Planning Act 2008, Application by Orsted Hornsea Project Four (UK) Limited (“Ltd”) for an Order Granting Development Consent for Hornsea Project Four Offshore Wind Farm

Relevant Representation

This document comprises the MMO's initial comments in respect of the DCO Application in the form of a relevant representation.

Figure 1. North Sea herring - Abundance of larvae <math>< 10\text{ mm}</math> (n/m^2) in the Buchan, Central (Banks) and Southern North Sea obtained from the IHLS in autumn and winter 2018/2019 (maximum circle size = 3500 n/m^2). (ICES 2019).

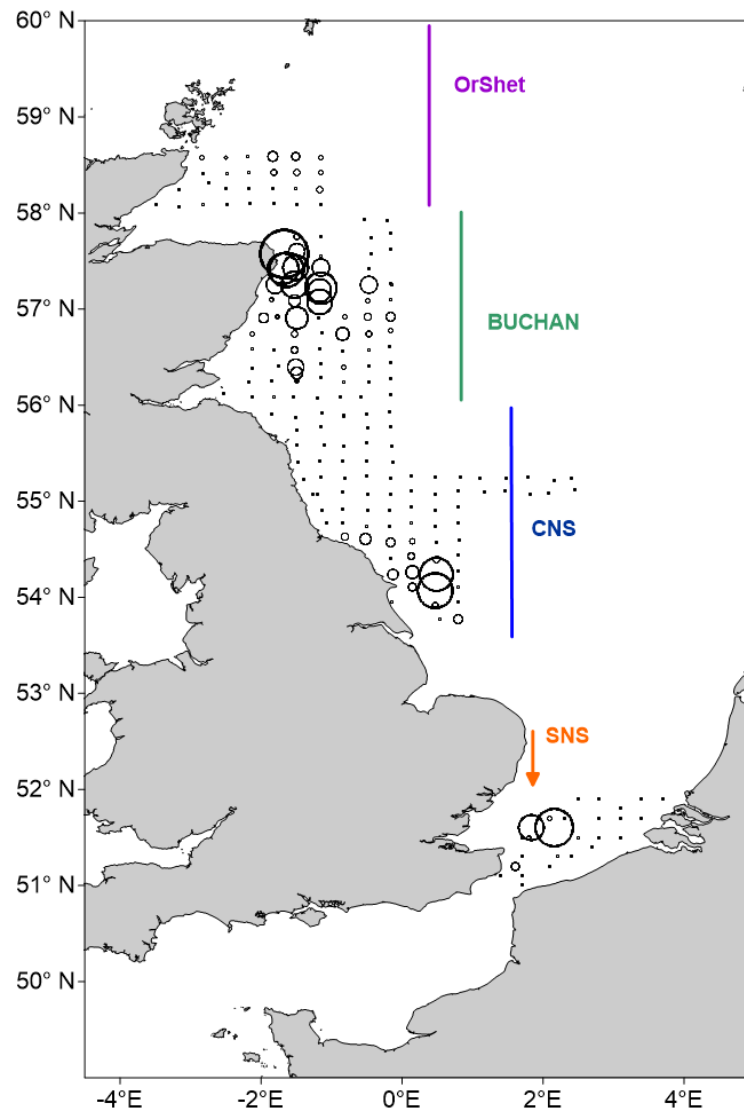
28. In addition to this more recent IHLS data are available for 2018-19 which has not been included in the heat maps. Whilst the MMO recognises that these data may not have been available at the time of writing of the PEIR and Draft ES, the mapped IHLS data for 2018-19 show that high larval densities occurred to the south and east of Flamborough Head rather than north (see Annex 1, Figure 1 of this response).

Figure 2. Historical Spawning Grounds taken from Coull *et. al* (1998)

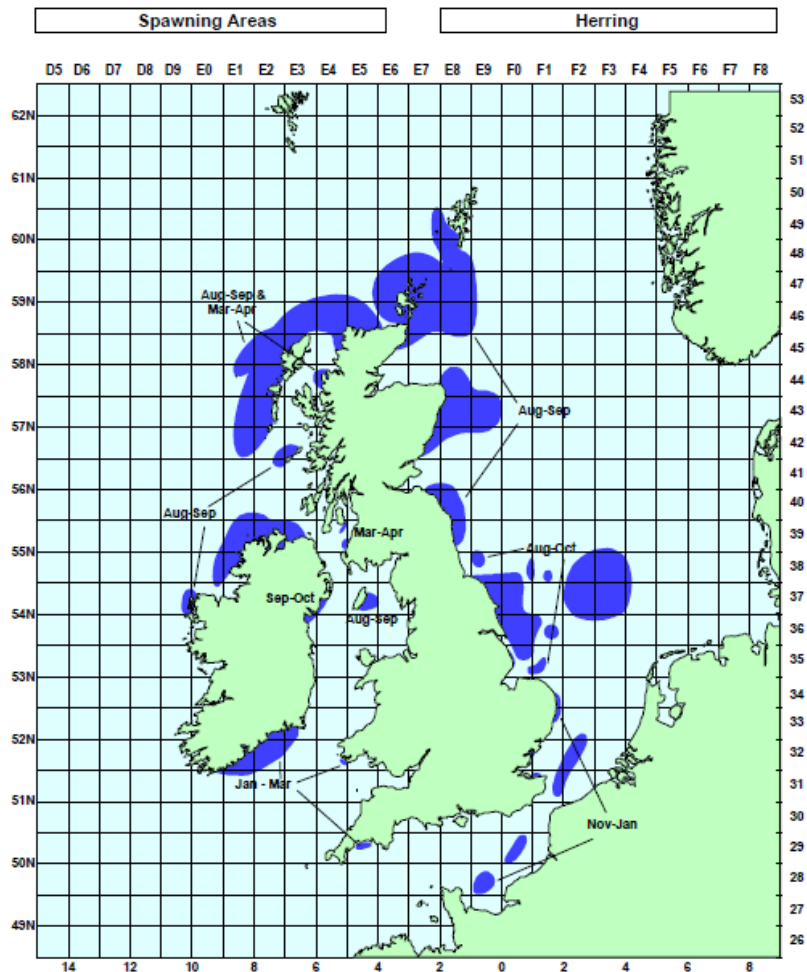
46. The MMO notes the herring spawning season for the Banks stock is from August to October inclusive - see Annex 1, Figure 2 of this response and Coull et. al (1998).

49. The Banks stock covers the spawning grounds along the North East coast of England. The spawning period for the Banks stock is considered to be from August to October inclusive (see Annex 1, Figure 2 of this report).
